ARCHITECTURAL REVIEW COMMISSION AGENDA REPORT

SUBJECT: REVIEW OF A 1,813-SF WAREHOUSE ADDITION AND ADDITION OF AN AMMONIA DIFFUSION TANK, RECEIVER TANK, AND COOLING TOWER TO THE EXISTING 3,743-SF GLACIER ICE WAREHOUSE FACILITY

PROJECT ADDRESS: 130 High Street

FILE NUMBER: ARCH-0535-2021

Figure 2: Elevation of project design and current site as seen from High Street (south).

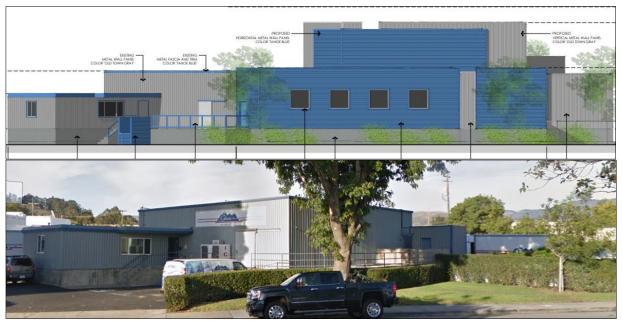
| Highlighted Sections | Discussion Items | |
|---|---|--|
| §2.2.C & D– Attention to detail & material selection | The project proposes vertical and horizontal articulation through wall offsets and use of material and material orientation. The ARC should review and discuss if the project achieves vertical and horizontal articulation and if the external treatments provide durability and authenticity, as well as beauty. | |
| §3.1.A. Overall design objectives for commercial projects | The project includes primarily rectilinear forms. The ARC should review and discuss if the project avoids appearing "boxy" by articulating the building form and creating building shapes with shade and shadow (2). | |
